A d d e n d u m

Iowa Department of Transportation

B.O.	Proposal ID	Proposal Work Type	County	Project Number	Addendum
108	91-C091-108	PPC PAVEMENT - NEW	WARREN	FM-C091(108)--55-91	21JUN108.A01

PCC PAVEMENT - NEW

Sheet B.1

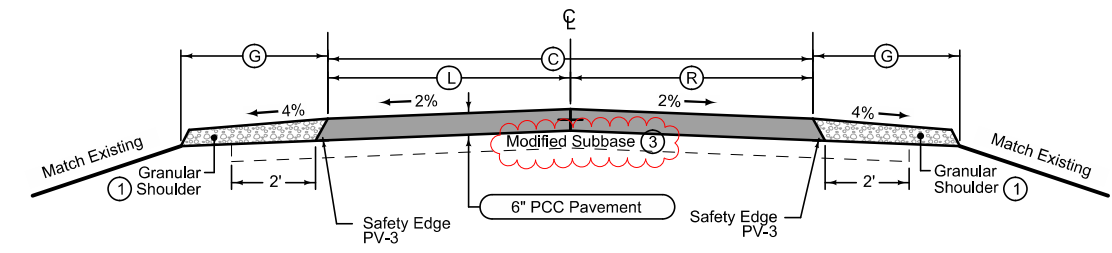
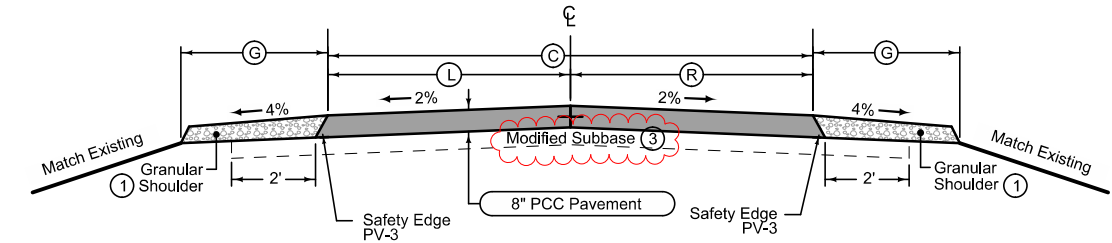
- Changed the shoulder width from 3 feet to 2 feet
- Added note to modified subbase
